Access Compliance Report

Public Rights-of-Way

Intersection ID: 28059	Main Street: CONGRESSIONAL CLUB DR	Cross Street: THREE LAKES DR	Location: NE
ADA ID: 84BD1A261A34	Ramp Type: PerpDiag	Initial Pass/Fail: Fail	Overall Compliance: No
Severity Score: 22.5			
Codes/Mitigation Info/Possible Solution		Field Measurements/Component Compliance

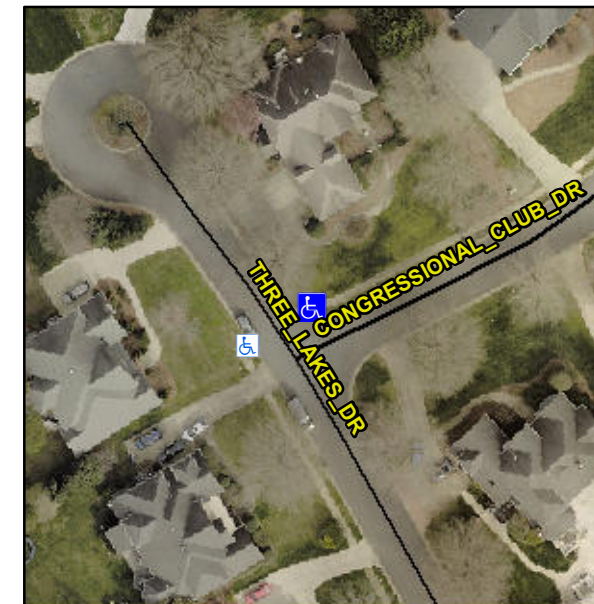
Not Found, R304.5.1, R304.2.2, R304.5.3

Compliance	Description	Data	Compliance	Description	Data
N/A	Ramp Length (in)	96.0	No	Ramp Slope (%)	9.2
No	Ramp Width (in)	46.0	No	Ramp XSlope (%)	3.8
N/A	Flare Type LT	N/A	N/A	Flare Type RT	N/A
N/A	Flare Slope LT (%)	N/A	N/A	Flare Slope RT (%)	N/A
N/A	Flare Traversable LT?	N/A	N/A	Flare Traversable RT?	N/A
N/A	Landing Length (in)	N/A	N/A	DWS Provided?	N/A
N/A	Landing Width (in)	N/A	N/A	DWS Contrast?	N/A
N/A	Landing Slope (%)	N/A	N/A	DWS Length (in)	N/A
N/A	Landing X Slope (%)	N/A	N/A	DWS Full Width?	N/A
N/A	Landing Curb? (Y/N)	N/A	N/A	DWS Offset (in)	N/A
N/A	Shared Landing?	N/A			
N/A	Gutter Ponding?	N/A	N/A	Gutter Slope (%)	N/A
N/A	Gutter Lip Ht (in)	N/A	N/A	Gutter X Slope (%)	N/A
N/A	Painted X Walk1?	No	N/A	Painted X Walk2?	No
	X Walk 1 Direction	To SW		X Walk 2 Direction	To SE
N/A	X Walk 1 Width (in)	N/A	N/A	X Walk 2 Width (in)	N/A
	X Walk 1 Slope (%)	4.1		X Walk 2 Slope (%)	1.2
	X Walk 1 X Slope (%)	1.5		X Walk 2 X Slope (%)	2.1

Remove & Replace Curb Ramp With Two New Directional Ramps or Equivalent.
